Audit of York Way cycle tracks

Camden Cycling Campaign, report on audit carried out on 24th June 2021

Figure 1. Goodsway junction looking north up the southbound side. There is no space for southbound cycling through this junction. Not even as shown on the Stage 1 scheme drawing.

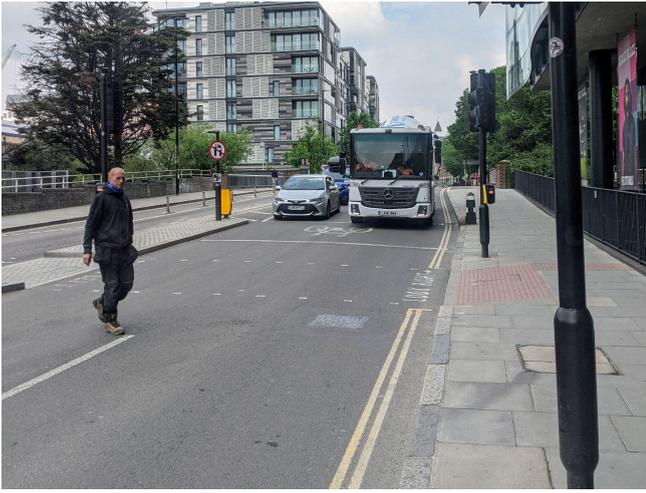
The experience riding southbound is very poor. There are two motor lanes and no cycle lane. See [Figure 1](#). The logos across the junction shown in the Phase 1 drawing are not painted on the road. Ideally, cyclists should be provided with a protected bypass lane southbound with a lane to the ASL for those wanting to turn right (as in the new Freight Lane scheme). The southbound approach is about 12.9m wide. The Phase 1 drawing shows how a pair of 2.2 m cycle lanes can be fitted in, provided that there is only one southbound motor lane. Without the central island it would be possible to fit in the Freight Lane design. The 'recent' improvements (installed in 2015) allow cyclists to turn right out of Goodsway and introduce a protected lane on the northbound approach.
